GasNet Principal Transmission System Review of Proposed New Facilities Investments

19 September 2007

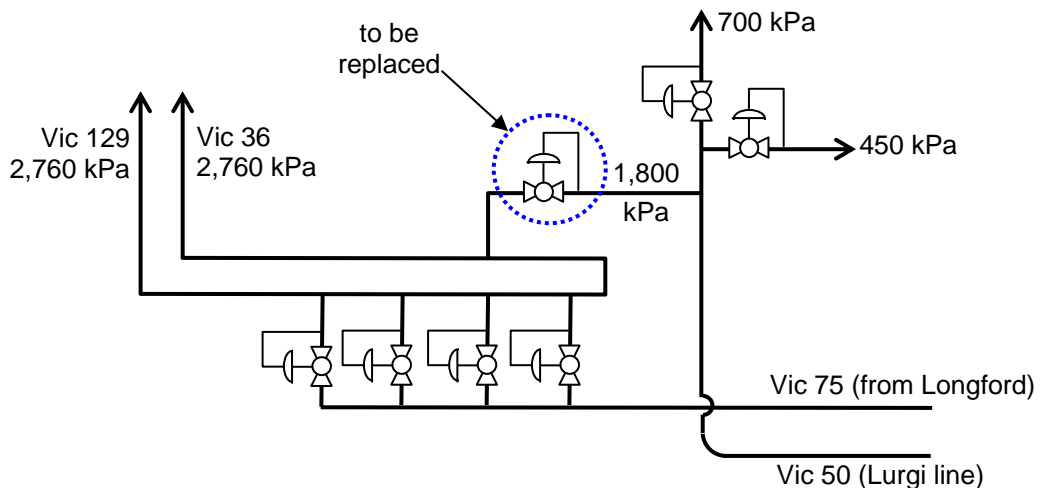
Certain gas pressure regulators installed at Dandenong³¹ have reached the end of their operating life and are to be replaced. The regulators in question are indicated in the following, simplified schematic.

GasNet's estimated cost for completion of the regulator modifications is \$420,000. The GasNet estimate compares favourably with the following independent cost estimate:
